**City of Portland, Maine - Building or Use Permit Application** 389 Congress Street, 04101, Tel: (207) 874-8703, FAX: 874-8716

Location of Construction: <b>13 Casco St</b>		Owner: <b>Quirk, John</b>	Phone:	Permit No: <b>950185</b>
Owner Address:	Leasee/Buyer's Name:	Phone:	Business Name:	<b>PERMIT ISSUED</b> Permit Issued: <b>FEB 17 1995</b>
Contractor Name: <b>Cunningham EQUIPMENT Security</b>	Address: <b>R 313 Reed St Portland, ME 04108</b>	Phone: <b>775-6568</b>		
Past Use: <b>Multi Fam</b>	Proposed Use: <b>Multi Fam w/fire alarm</b>	COST OF WORK: <b>\$ 9,700.00</b>	PERMIT FEE: <b>\$ 70.00</b>	<b>CITY OF PORTLAND</b> Zone: <b>D-3</b> CBL: <b>037-C-006</b> Zoning Approval: <b>3/14/95</b> Special Zoning or Revisions: <input type="checkbox"/> Shoreland <input type="checkbox"/> Wetland <input type="checkbox"/> Flood Zone <input type="checkbox"/> Subdivision <input type="checkbox"/> Site Plan major <input type="checkbox"/> minor <input type="checkbox"/> minor
Proposed Project Description: <b>Install Fire Alarm System</b>		FIRE DEPT. <input checked="" type="checkbox"/> Approved <input type="checkbox"/> Denied Signature: <i>[Signature]</i>	INSPECTION: <b>Fire Alarm</b> Use Group: <b>

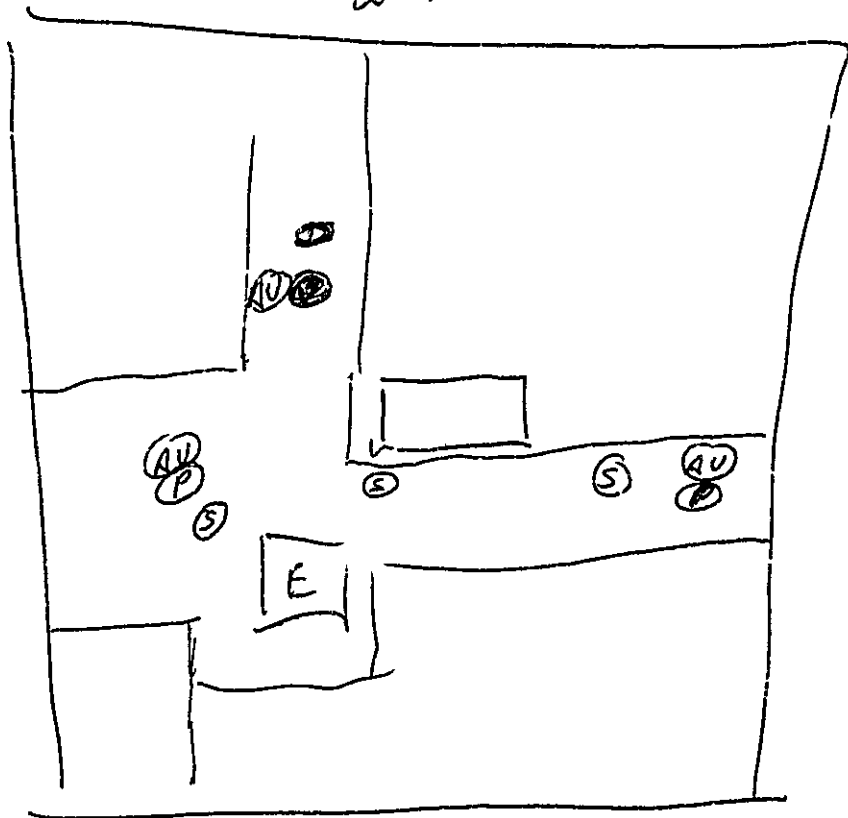
Conditions of Approval or Denial:

1. All required Fire Alarm systems shall have the capability of "Zone Disconnect" via switches or key pad program provided the method is approved by the Fire Prevention Bureau.
2. All remote annunciators shall have a visible "trouble" indicator along with the Fire Alarm "Zone" indicators.
3. Any Master Box connected to the Municipal Fire Alarm System shall have a supervised Municipal Disconnect Switch.
4. All Master Box locations shall be approved by the Fire Department Director of Communications. A Master Box shall be located so that the center of the box is (5') five feet above finished floor.
5. All Master Box locations are required to have a locked box ( knockbox )
6. A fire alarm acceptance report shall be submitted to the portland Fire Department
